Rezoning Transportation Analysis

Petition Number: Insert Zoning Petition #2021-200

Date	Description
12-28-21	First Review (TNM)
01-27-2022	Second Review (KP)

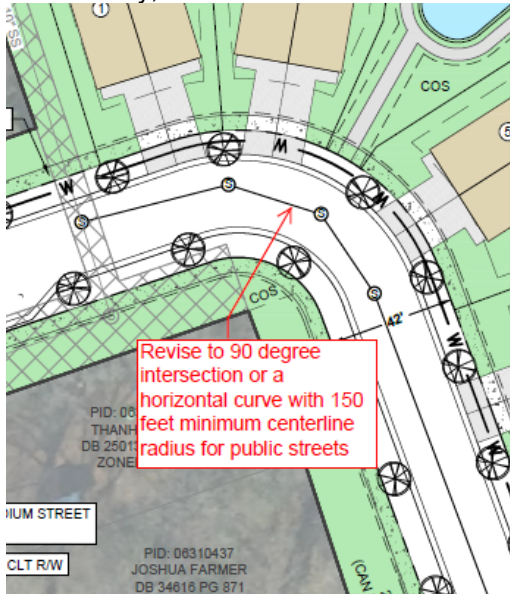
- ~~1. **Curb line:** The proposed zoning district has a setback measured from back of the existing curb line.
a. **Wildwood Avenue:** The future location of curb and gutter is in its existing location.~~

~~Label and dimension the curb and gutter from the centerline for each road on the site plan.~~

- ~~3. Revise site plan and conditional note(s) to commit to dedicating 28-foot of right-of-way from the site's proposed road centerline (56-foot total). The site plan shall label and dimension the right-of-way from the proposed road centerline.~~
- ~~4. Revise site plan and conditional note(s) to commit to construct an 8-foot planting strip, and 6-foot sidewalk on Wildwood Avenue and the site's internal roads per Chapter 19. The site plan shall label and dimension both items from the back of curb and the road centerline.~~
- ~~5. Revise site plan to propose at 90-degree intersection in the location of the horizontal curve. Alternatively, a horizontal curve can be installed with a minimum centerline radius of 150-feet.~~

- ~~6. Revise site plan to propose ADA ramps at the intersection of Wildwood Avenue and the internal public road.~~

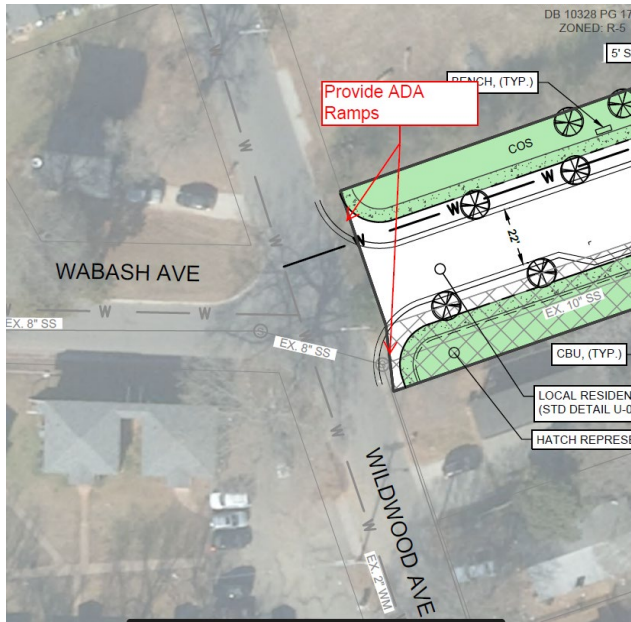
~~7. Site plan and conditional note(s) revisions are needed identify the internal streets as public streets.~~

~~8. Revise Transportation Note 6 to state commit to dedication and fee simple conveyance of all rights-of-way to the City before the site's first building certificate of occupancy is issued is needed. CDOT requests rights-of-way set at 2' behind back of sidewalk where feasible.~~
